**Subject:** RE: CHT conversations with Bridgepoint

**Subject:** RE: Bridgepoint Project input

PLANS ESTEAD ROAD, CHAPEL HILL, NC - CRANGE COUNTY
BRIDGEPOINT
L. USE PERMIT MODIFICATION P
FOR
KB HOME CAROLINAS

BRIDGEPOINT SPECIAL USE PERMIT

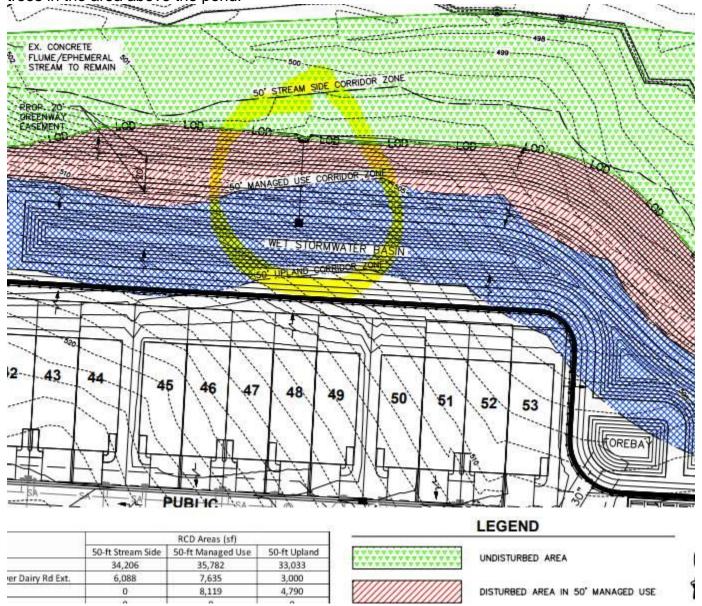
n my previous email it seems my inset diagram did not show up - at least from what I can see. So I am attaching the inset diagram to this email so you can see what I am referencing in this paragraph. Sorry you are getting two emails but I want to be clear in my point

To be clearer, there seems to be three zones at the north end of the development – pond, middle zone where greenway is proposed and area near creek. (the inset diagram) I have attached the plans that are on the Bridgepoint website. PLEASE look carefully at page 8 of the attached plans. (Ms Grahn in her email to me said they are also addressed on page 6 landscape and trees and page 7 planting plan of the plans submitted 10/16/2020.) That middle zone- the disturbed area shown in red- has <u>ALL</u> the trees being cut. If trees are valued enough to be planted in

the development, then trees should be valued enough that they do not have to be totally chopped down in the nondevelopment areas. Huge old trees are being cut in the development area. Save old trees in the area above the pond.
